Access Compliance Report

Public Rights-of-Way

(Curb Ramps)

Intersection ID: 3352	Main Street: DAVIS_RIDGE_DR	Cross Street: FALLS_RIDGE_LN	Location: NE
ADA ID: 07C6BC8DDF2F	Ramp Type: Perp	Initial Pass/Fail: Fail	Overall Compliance: No
		Severity Score: 1.25

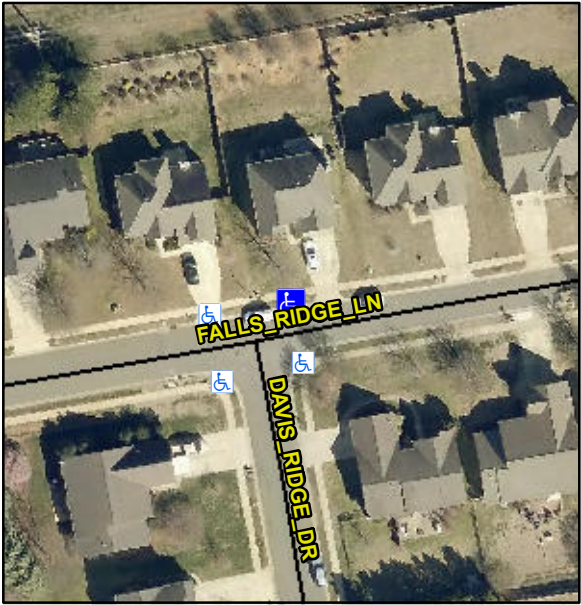
Codes/Mitigation Info/Possible Solution		Field Measurements/Component Compliance			
	Possible Solutions:	Compliance	Description	Data	Compliance
	Remove & Replace Entire Ramp.	Yes	Ramp Length (in)	48.5	Yes
		Yes	Ramp Width (in)	48.0	Yes
		N/A	Flare Type LT	N/A	N/A
		N/A	Flare Slope LT (%)	N/A	N/A
		N/A	Flare Traversable LT?	N/A	N/A
		N/A	Landing Length (in)	N/A	N/A
		N/A	Landing Width (in)	N/A	N/A
		N/A	Landing Slope (%)	N/A	N/A
		N/A	Landing X Slope (%)	N/A	N/A
<p>Surveyor Notes:</p> <p>N/A</p> <p>PROW/ADA:</p> <p>Not Found</p>		N/A	Flare Type RT	N/A	N/A
		N/A	Flare Slope RT (%)	N/A	N/A
		N/A	Flare Traversable RT?	N/A	N/A
		N/A	DWS Provided?	N/A	N/A
		N/A	DWS Contrast?	N/A	N/A
		N/A	DWS Length (in)	N/A	N/A
		N/A	DWS Full Width?	N/A	N/A
		N/A	DWS Offset (in)	N/A	N/A
		N/A	Shared Landing?	N/A	N/A
		N/A	Gutter Ponding?	N/A	N/A
		N/A	Gutter Lip Ht (in)	N/A	N/A
		N/A	Painted X Walk1?	No	N/A
			X Walk 1 Direction	To S

N/A	X Walk 1 Width (in)	N/A	N/A
			X Walk 1 Slope (%)	3.1	
			X Walk 1 X Slope (%)	5.9	
		N/A	Ramp inside XWalk1?	N/A	N/A
			Road Slope (%)	N/A	
			Road X Slope (%)	N/A	
		N/A	Any Obstructions?	N/A	N/A
Total Cost:		\$	1850.00		
			Obstruction Type		
				N/A	N/A
				Yes	Surface Condition? (G/P)
					Good
